STANADYNE[®]
Diesel Systems

SERVICE BULLETIN

SUBJECT: NEW PUMP MODEL FOR 1999 MODEL YEAR GM 6.5L DIESEL

A new DS pump model has been released for the 1999 model year GM 6.5L diesel engine. It is model DS4831-5459, GM Part Number 12561405. It is essentially the same as the previous model DS4831-5288 with a few component and calibration changes as outlined within. The new 5459 model supersedes model 5288 for both production and service.

Figure 1

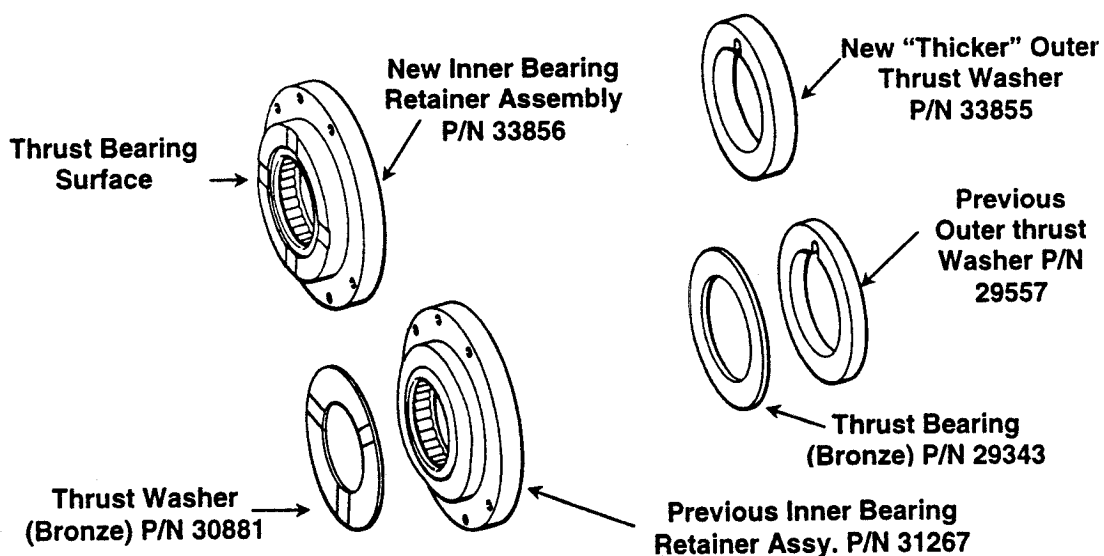
The bronze thrust bearings used in the DS pump drive shaft/transfer pump group have been eliminated. A new thicker inner bearing retainer assembly, P/N 33856, has been released. It incorporates the axial thrust bearing surface and supersedes the previously used 31267 inner bearing retainer. At the other end of the drive shaft/transfer pump group is a new thicker thrust washer, P/N 33855. It supersedes the previous 29557 washer and 29343 bronze thrust bearing. The previous and new configurations are as shown in Figure 1.

All DS pump specifications have been revised to reflect this change and all are to be serviced with the new components, when required, as follows:

1. If a 31267 inner bearing retainer assembly requires replacement, discard it and the 30881 thrust bearing and replace it with the 33856 inner bearing retainer assembly.
2. The 30881 will continue to be available for service. Therefore, if only a 30881 thrust bearing requires replacement, you may replace the thrust bearing and reuse the previous 31267 inner bearing retainer assembly.
3. If the 29557 outer thrust washer and/or the 29343 bronze thrust bearing require replacement, discard both parts and replace them with the current 33855 outer thrust washer.

Figure 2

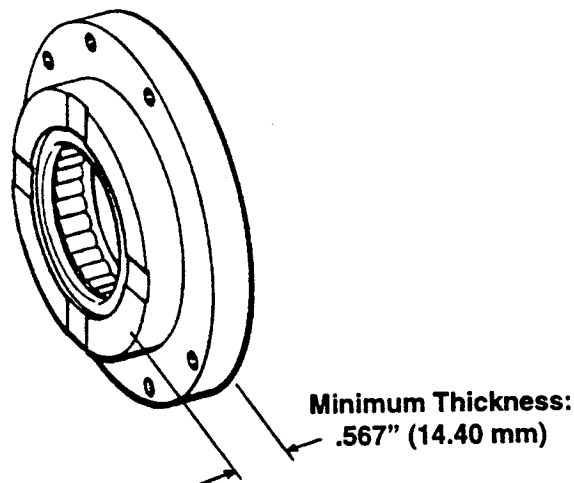
Minor scoring and polishing on the axial thrust face of the new 33856 inner bearing assembly is considered normal. The 33856 should only be replaced during service when the thickness of the assembly is less than 0.567 inches (14.40 mm) as shown in Figure 2.
